Comment (Comment r02-119, r02-70 clause 145.4.1 page 217 line 39)

Annex A – PSE – PD configurations for specifying isolation.

Figure 1: Dual-signature, single load PD.

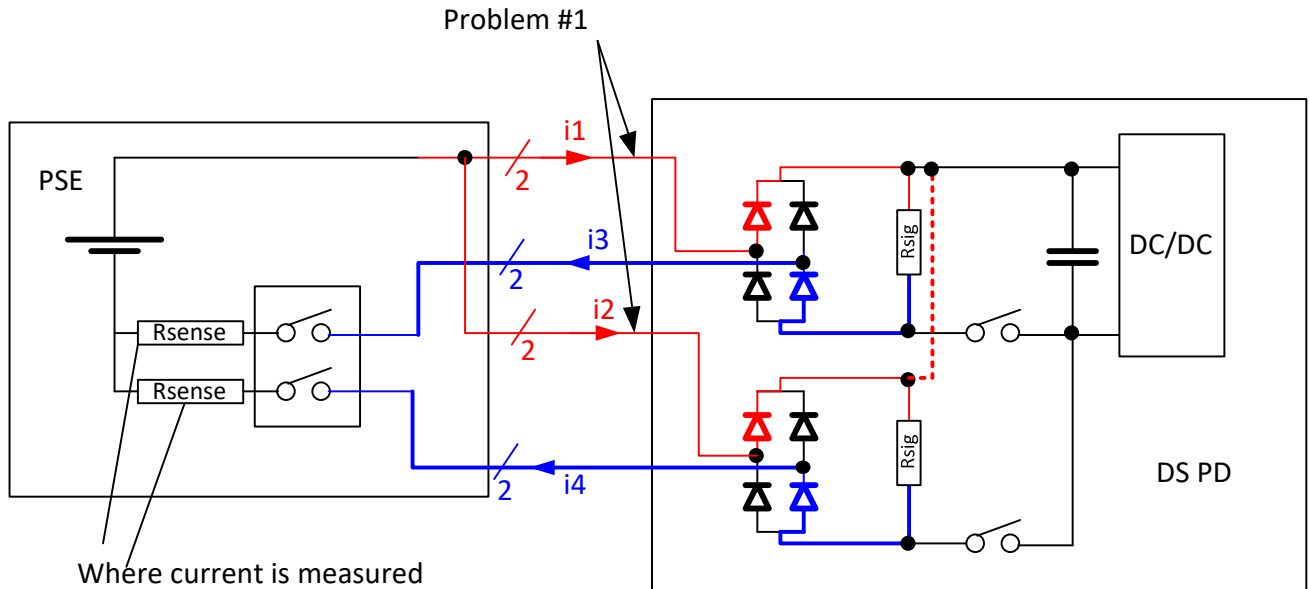
Figure 1:

- Switching on the negative is mandatory
- Measuring current on the negative when switching on the negative is the only possible choice for 4-pair operation since measuring on the positive will result with pairs currents that are not correlated to the negative pairs currents due to unbalance. As a result, it is guaranteed only in the negative pairs, that PSE will support PD successfully when measuring the pair current for connection check, detection and classification circuits in dual-signature PDs.
- In addition, the positive side is tied together at the PSE side which effectively, tied the positive pairs at the PD side as well.

Figure 2: Dual-signature, dual load PD.

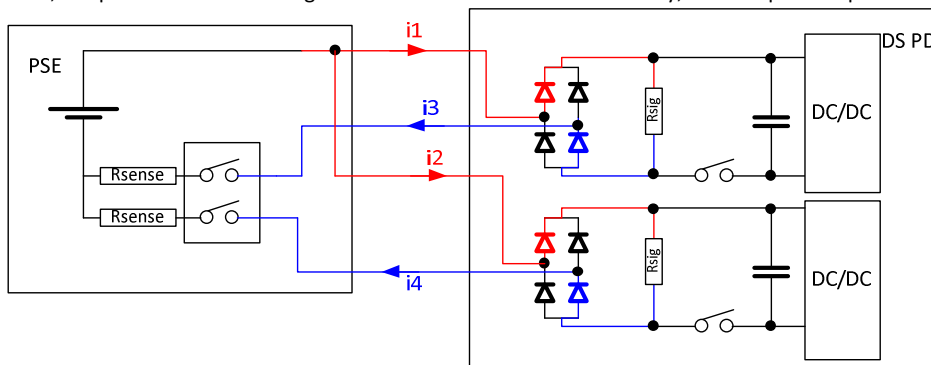
Figure 2:

By definition, the positive pairs and negative pairs are isolated in the PD primary side (secondary may have common GND and typically this is the case). However, since as in the previous case the PSE is required to support switching on the negative pairs, PD is not guaranteed to be supported on the positive pairs making the isolation requirements on the PD positive pairs with no value.
